PROJECT NUMBER: PR-2019-002184
 Application Number: SI-2019-00379

GUARDIAN STORAGE OSUNA ROAD

SITE PLAN - DRB

AMENDMENT AUGUST 24, 2021

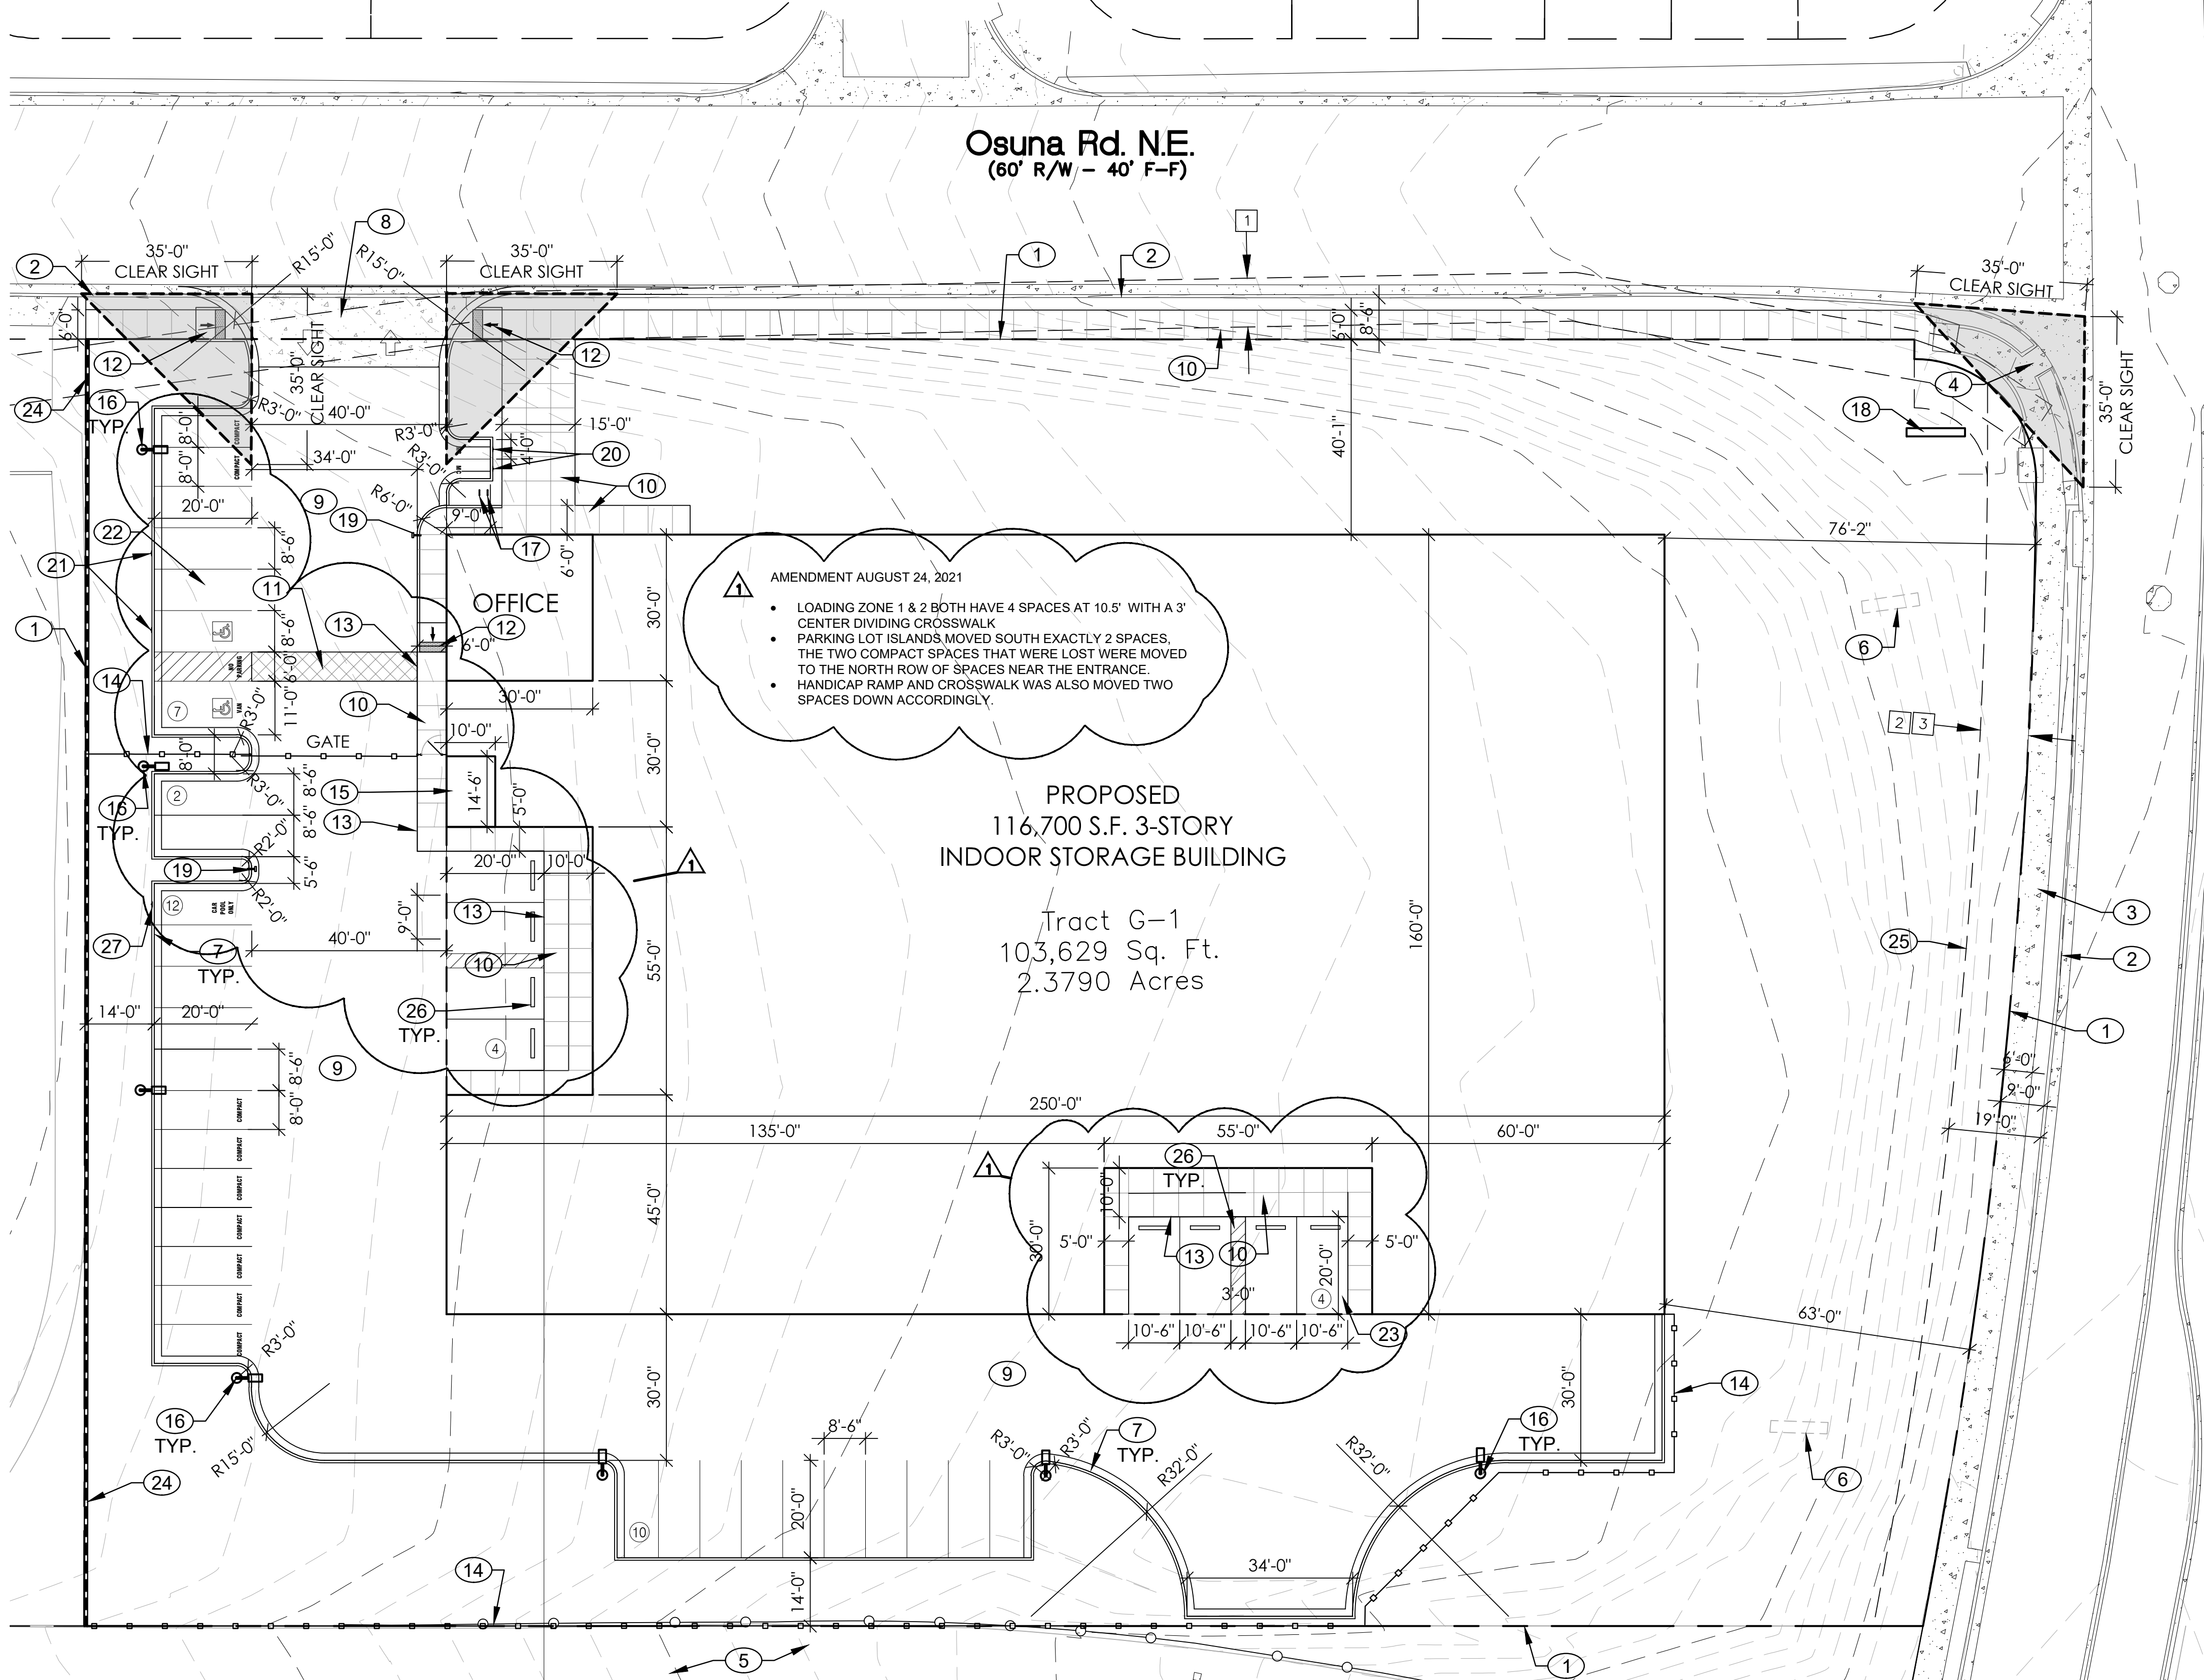
- LOADING ZONE 1 & 2 BOTH HAVE 4 SPACES AT 10.5' WITH A 3' CENTER DIVIDING CROSSWALK
- PARKING LOT ISLANDS MOVED SOUTH EXACTLY 2 SPACES. THE TWO COMPACT SPACES THAT WERE LOST WERE MOVED TO THE NORTH ROW OF SPACES NEAR THE ENTRANCE.
- HANDICAP RAMP AND CROSSWALK WAS ALSO MOVED TWO SPACES DOWN ACCORDINGLY.

OFFICE: 3.5 SPACE PER 1,000 SF GFA	
SELF STORAGE: 1 SPACE PER 3,000 SF GFA	
TOTAL PARKING REQUIRED/PROVIDED:	41/42
REQUIRED OFFICE (900 SF):	3
REQUIRED SELF-STORAGE (115,800 SF):	+38
TOTAL REQUIRED SPACES:	41
PROVIDED STANDARD SPACES:	29
PROVIDED COMPACT SPACES:	9 (21%)
PROVIDED CAR POOL SPACES:	+4 (1 SPACE = 4 CREDITS)
TOTAL PROVIDED SPACES:	42
HANDICAPPED REQUIRED/PROVIDED:	2/2
MOTORCYCLE PARKING REQUIRED/PROVIDED:	2/2
BICYCLE REQUIRED/PROVIDED:	4/4
